Access Compliance Report

Public Rights-of-Way

(Curb Ramps)

Intersection ID: 5967	Main Street: N_TRYON_ST	Cross Street: MCCULLOUGH_DR	Location: SE
ADA ID: 501CB9097EC9	Ramp Type: Perp	Initial Pass/Fail: Fail	Overall Compliance: No
			Severity Score: 21.25

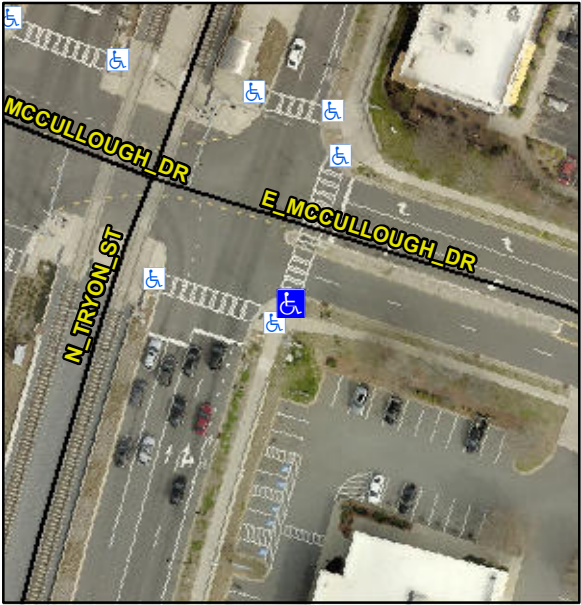
Codes/Mitigation Info/Possible Solution			Field Measurements/Component Compliance		
	Possible Solutions:		Compliance	Description	Data
	Remove & Replace Entire Ramp.		Yes	Ramp Length (in)	6.3
			No	Ramp Width (in)	6.1
			N/A	Flare Type LT	N/A
			N/A	Flare Slope LT (%)	N/A
			N/A	Flare Traversable LT?	N/A
			N/A	Landing Length (in)	N/A
			N/A	Landing Width (in)	N/A
			N/A	Landing Slope (%)	N/A
			N/A	Landing X Slope (%)	N/A
<p>Surveyor Notes:</p> <p>N/A</p> <p>PROW/ADA:</p> <p>Not Found, R304.5.1, R304.5.3</p>			N/A	Flare Type RT	N/A
			N/A	Flare Slope RT (%)	N/A
			N/A	Flare Traversable RT?	N/A
			N/A	DWS Provided?	N/A
			N/A	DWS Contrast?	N/A
			N/A	DWS Length (in)	N/A
			N/A	DWS Full Width?	N/A
			N/A	DWS Offset (in)	N/A
			N/A	Shared Landing?	N/A
			N/A	Gutter Ponding?	N/A
			N/A	Gutter Lip Ht (in)	N/A
			N/A	Painted X Walk1?	N/A
			Yes	X Walk 1 Direction	N/A
			To NE	X Walk 2 Direction	N/A
			N/A	X Walk 1 Width (in)	N/A

N/A	X Walk 2 Width (in)	N/A
			0.5	X Walk 1 Slope (%)	N/A
			5.8	X Walk 2 Slope (%)	N/A
			N/A	X Walk 1 X Slope (%)	N/A
			N/A	X Walk 2 X Slope (%)	N/A
			Yes	Ramp inside XWalk1?	N/A
			N/A	Ramp inside XWalk2?	N/A
			N/A	Road Slope (%)	N/A
			N/A	Clear Space?	N/A
			N/A	Clear Space to XWalk (in)	N/A
			N/A	Road X Slope (%)	N/A
			N/A	Storm Grate/Utility Hazard?	N/A
			N/A	Storm Grate/Utility Type	N/A
			N/A	Any Obstructions?	N/A
			N/A	Obstruction Type	N/A
Total Cost:		\$ 1850.00	Yes	Surface Condition? (G/P)	Good
